Model: Model L2a	Date: 9-Sep-04	No.: RH914001b
------------------	----------------	----------------

Subject: Firmware History		Prepared by: T. Shintani	
From: 1st Technical Support Sec. Service Support Dept.			
Classification:	<input type="checkbox"/> Troubleshooting <input type="checkbox"/> Mechanical <input type="checkbox"/> Paper path <input type="checkbox"/> Other (      )	<input type="checkbox"/> Part information <input type="checkbox"/> Electrical <input type="checkbox"/> Transmit/receive	<input checked="" type="checkbox"/> Action required <input type="checkbox"/> Service manual revision <input type="checkbox"/> Retrofit information

Model: Model L2a/b/c		Date: 13-May-09	No.: RH914007
Subject: Sheet Guide Paper (Paper Feed)		Prepared by: Y. Gaman	
From: 1st Tech. Support Sec. Service Support Dept.			
Classification:	<input type="checkbox"/> Troubleshooting <input type="checkbox"/> Mechanical <input type="checkbox"/> Paper path <input type="checkbox"/> Product Safety	<input checked="" type="checkbox"/> Part information <input type="checkbox"/> Electrical <input type="checkbox"/> Transmit/receive <input type="checkbox"/> Other (     )	<input type="checkbox"/> Action required <

### 5.Paper Feed (H914/H915)

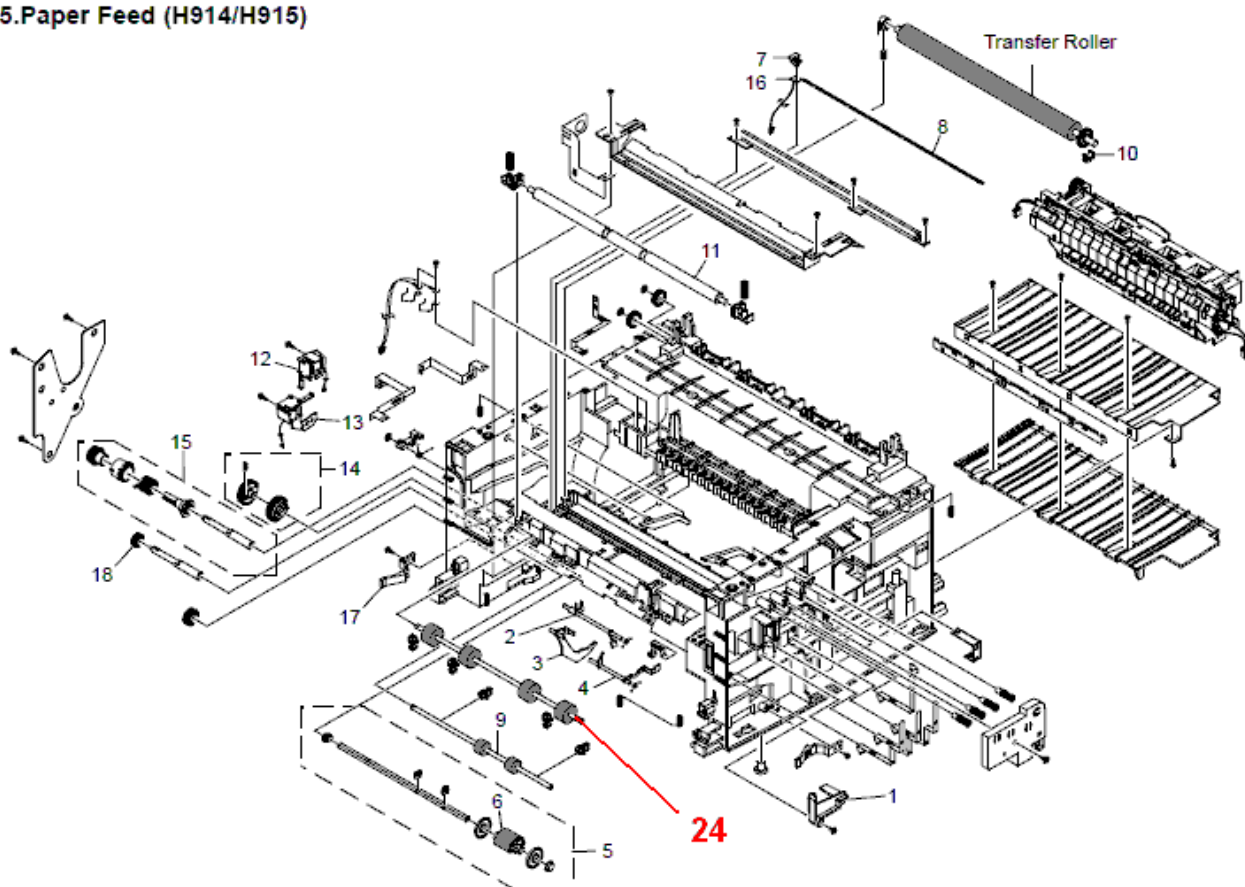
New Part	Description	Q'ty	Int	Page	Index	Note
G9601107	Feed Roller	1		12	24

**Change:** This part was added.

**6.Paper Feed (H916)**

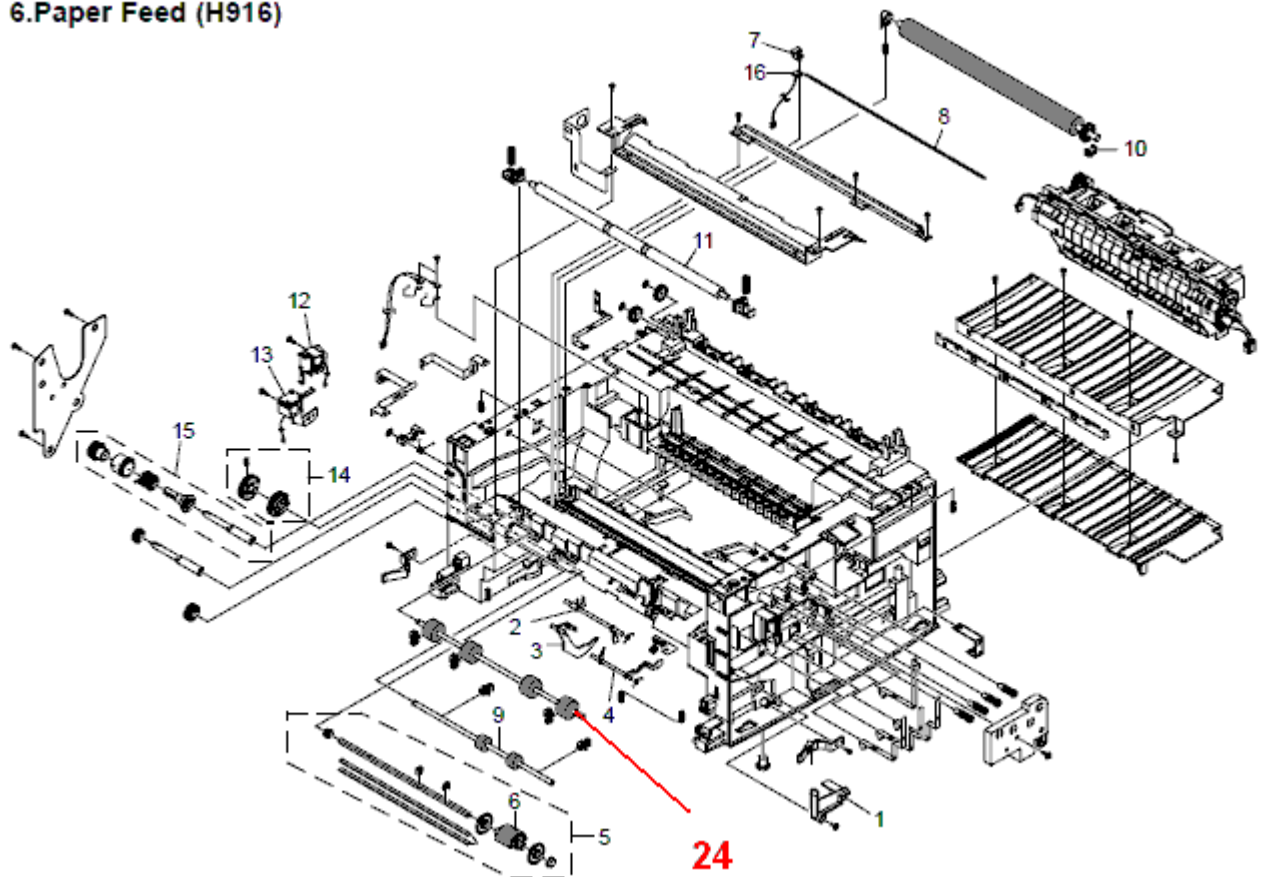
New Part	Description	Q'ty	Int	Page	Index	Note
G9601107	Feed Roller	1		12	24

## 5.Paper Feed (H914/H915)

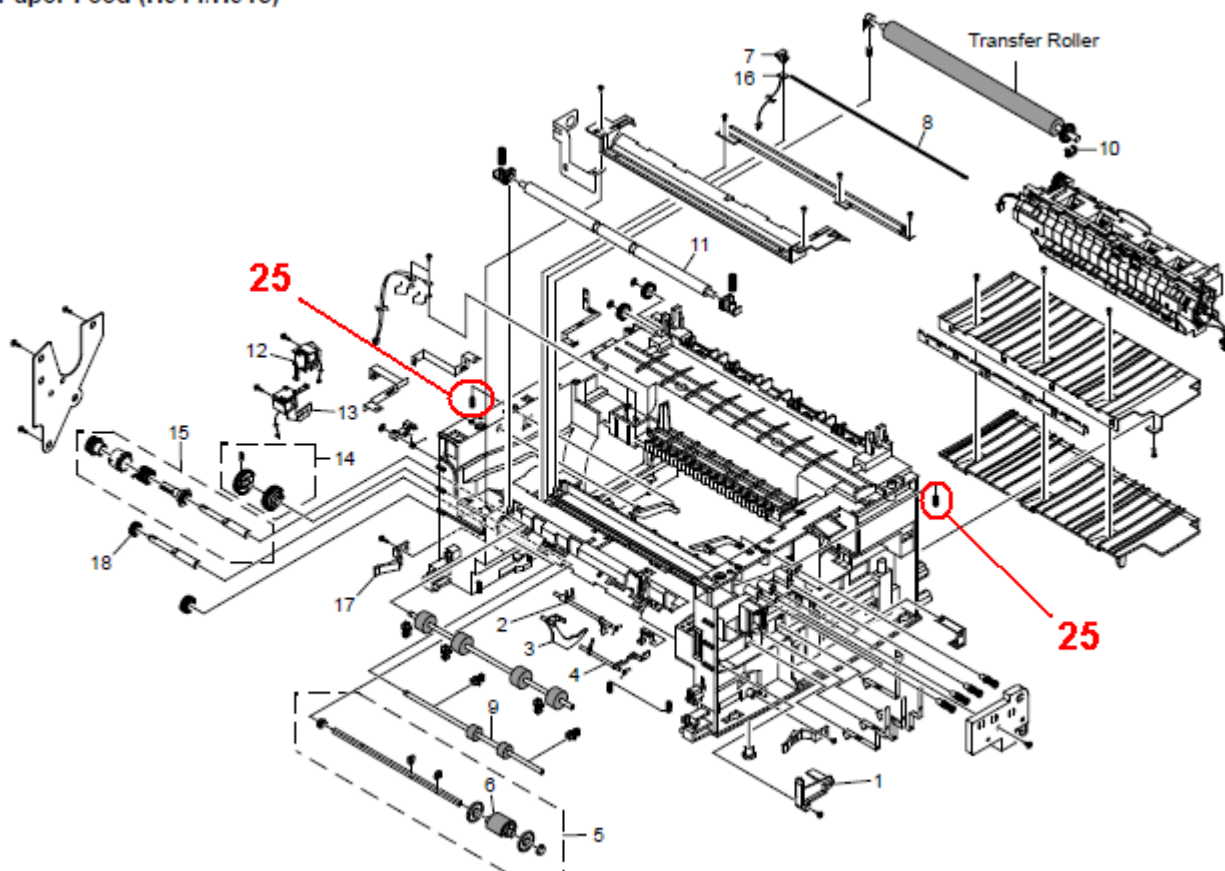
New service part is added.

Request from the field.

New Part #	Description	Q'ty	Int.	Page	Index	Note
G1861203	SPRING - GUIDE	2	-	11	25
